MEMORANDUM

RE: **Response to Comments – VAI**
Neck Farm Estates
13 Neck Road - Lancaster, MA

MDM Transportation Consultants, Inc. (MDM) has prepared the following responses to transportation-related comments as issued in a letter by Vanasse & Associates, Inc. dated March 8, 2024. To facilitate review, specific comments are paraphrased with corresponding responses.

AutoTurn Analysis - Jetta

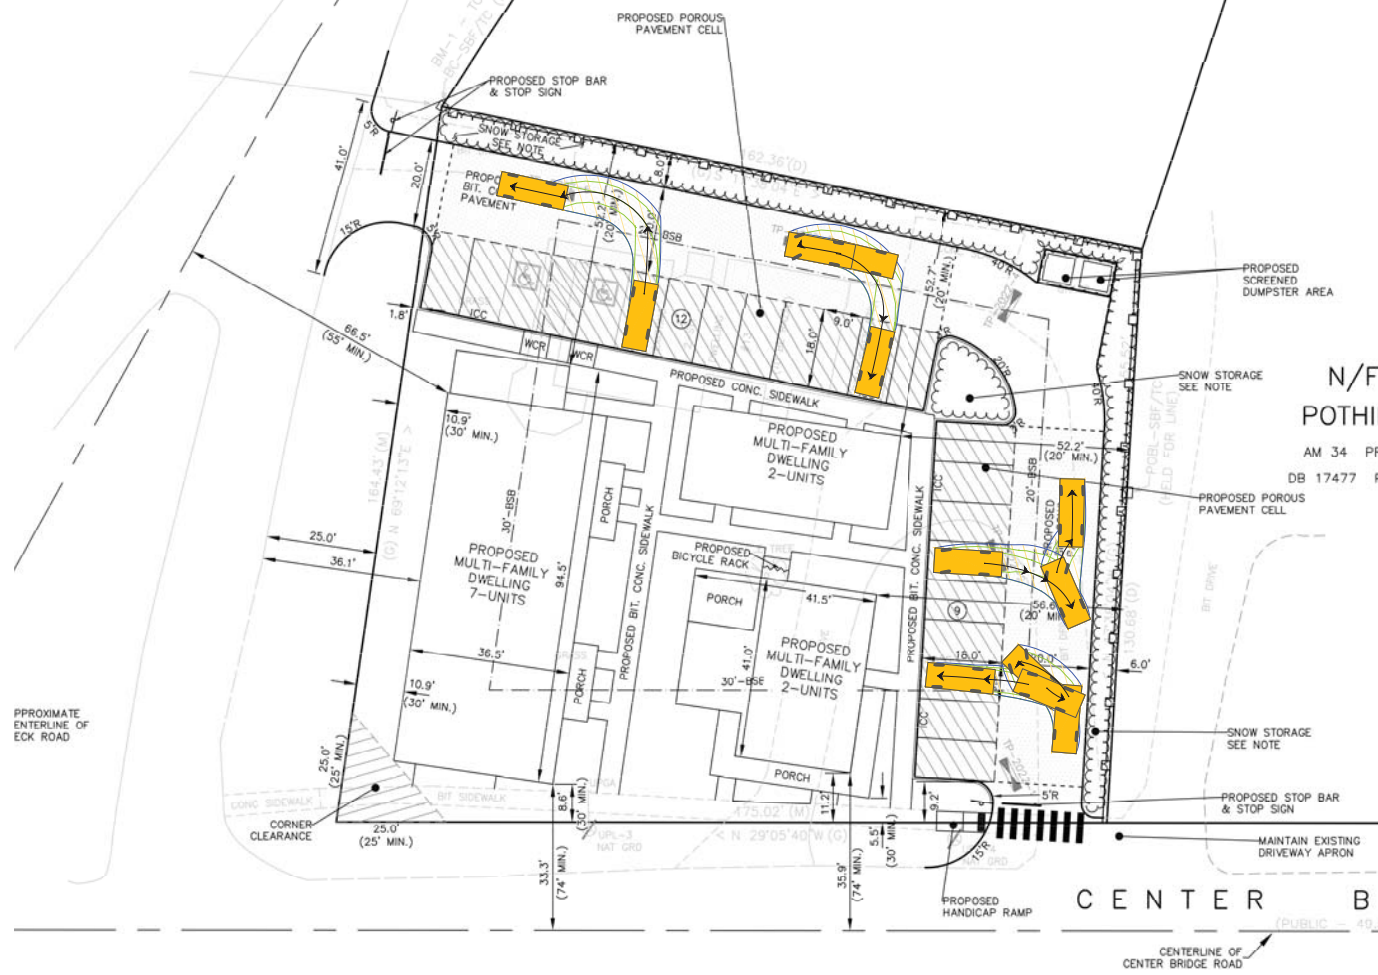
Comment S1: *“The Project site driveways and the internal drive should be widened to a minimum of 23-feet (24 feet is suggested) in order to accommodate parking maneuvers or a vehicle turning analysis should be provided using the AutoTurn© software that demonstrates that vehicles can enter and exit the proposed parking spaces without maneuvering into the adjacent parking space. Alternatively, consideration could be given to establishing a one-way circulation pattern and reconfiguring the parking to be angled.”*

Response: Due to the low-turnover nature of the residential use of the Site the standard parking space design (9'x18') with compact aisle width (20 feet) will adequately accommodate the needs of the proposed development. AutoTurn exhibits indicating ample maneuvering area at the 20-foot aisle are included in the **Attachments**. MDM notes that a 20-foot-wide cross-section is consistent with the AASHTO design criteria for very low volume local roadways, which is in line with likely very low-volume characteristics within the parking areas.

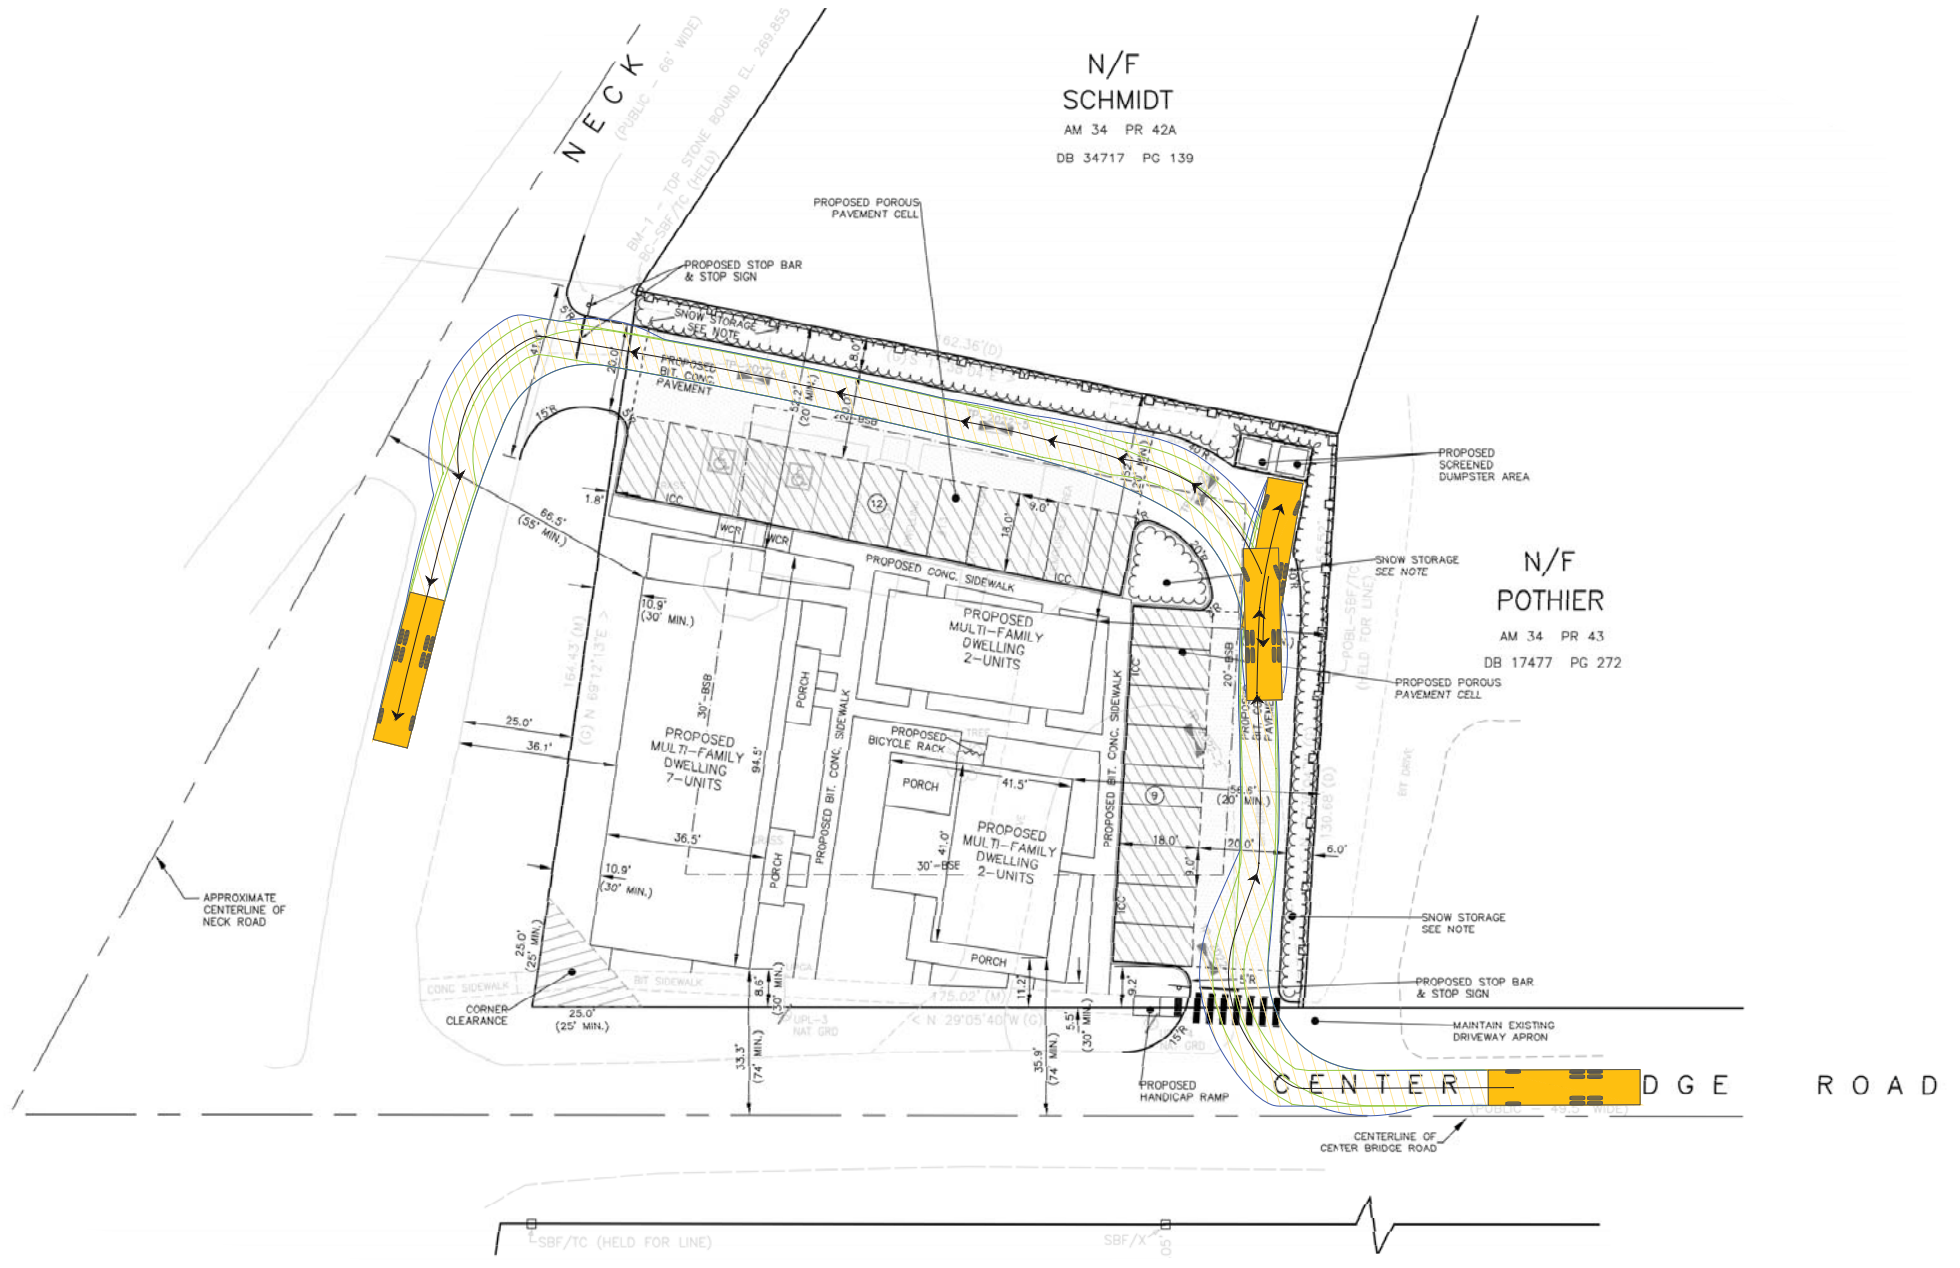
Comment S3: *“A narrative should be provided describing how tenant moves will be accommodated and trash/recycling managed, including the scheduling of such activities and where they will occur for each building.”*

Response: The “welcome packet” will provide the name and contact information for the transportation coordinator who will advise tenants on move in/move out and delivery protocols and will inform tenants on the use of the dumpsters and trash removal protocol. The current design will include the use of dumpsters for trash and recycling for pickup by a trash vendor (as needed). For reference, the location of the dumpsters enclosure as prepared by Hancock Associates and AutoTurn exhibit indicating ample maneuvering area for trash removal are included in the **Attachments**.
